Browns Ferry Nuclear Plant, Unit 3
Facility Operating License No. DPR-68
NRC Docket No. 50-296

Subject: **Response to NRC Request for Additional Information Regarding Relief Request 3-ISI-26**

Request for Relief 3-ISI-26, Updated Risk Informed Inservice Inspection Program

TVA Responses to NRC Request for Additional Information Questions

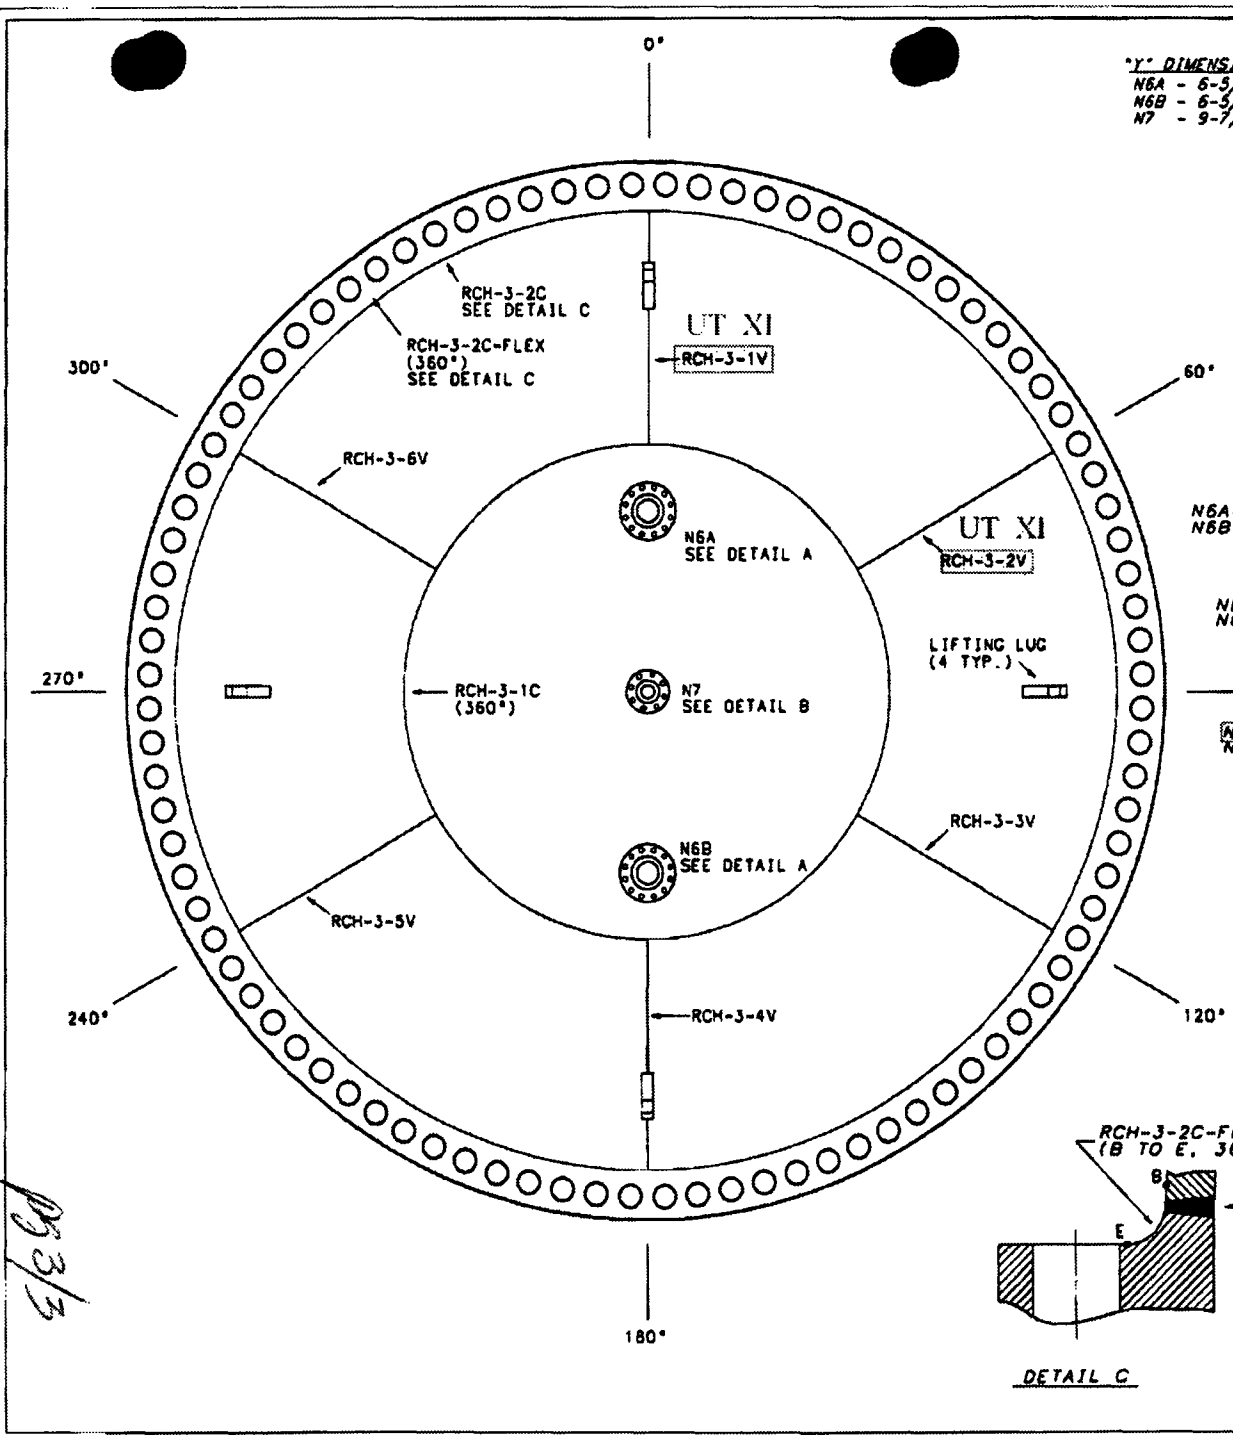
NRC Question 1: *Have any visual examinations been conducted on the associated nozzle inner radius area, such as those allowed by ASME Code Case N-648-1, "Alternative Requirements for Inner Radius Examinations of Class 1 Reactor Vessel Nozzles, Section XI, Division 1"?*

NRC Question 2: *If any such inspections have been completed, were any indications found in the associated N6A-NV nozzle-to-vessel head weld? If so, please describe each indication in detail.*

TVA Response: The inner radius of vessel (head) nozzle N6A (N6A-IR) was visually examined during the Unit 3 Cycle 13 (U3C13) refueling outage (March 25, 2008) that was in the first period of the third inservice inspection interval. This inspection was in accordance with ASME Code Case N-648-1. Please see Reference Report R-032 in Enclosure 2.

TVA Response: No indications were found when the inner radius of vessel (head) nozzle N6A (N6A-IR) was visually examined during the U3C13 refueling outage (March 25, 2008).
